Subject: 10CFR21 Reporting of Defects and Non-Compliance -
Engine Systems, Inc. Report No. 10CFR21-0094, Rev. 0

Plunger and Barrel Assembly, Fuel Injection Pump
Haynes P/N 9041367

10CFR21 REPORTING OF DEFECTS AND NON-COMPLIANCE

COMPONENT: Plunger and barrel assembly, fuel injector pump
Haynes P/N 9041367

Figure 1: Typical pump barrel
(see references on page 3)

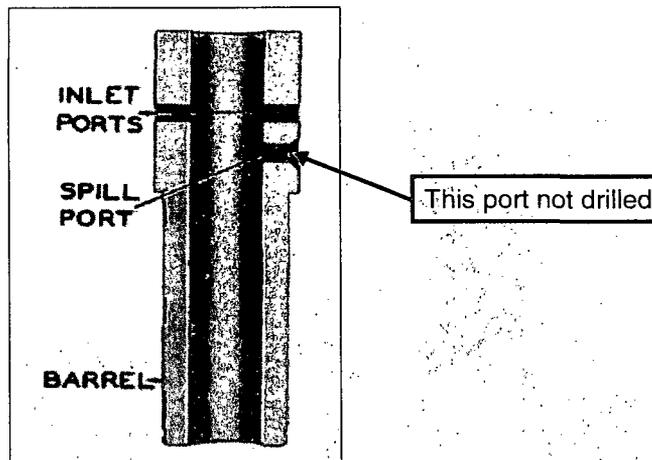
The pump barrels (Haynes P/N 9041375) were manufactured with only 2 drilled ports instead of 3 drilled ports as required by the final configuration print for this part number barrel. The notification also states that use of the supplied barrels in a fuel injector pump would result in the pump not passing functional calibration requirements.
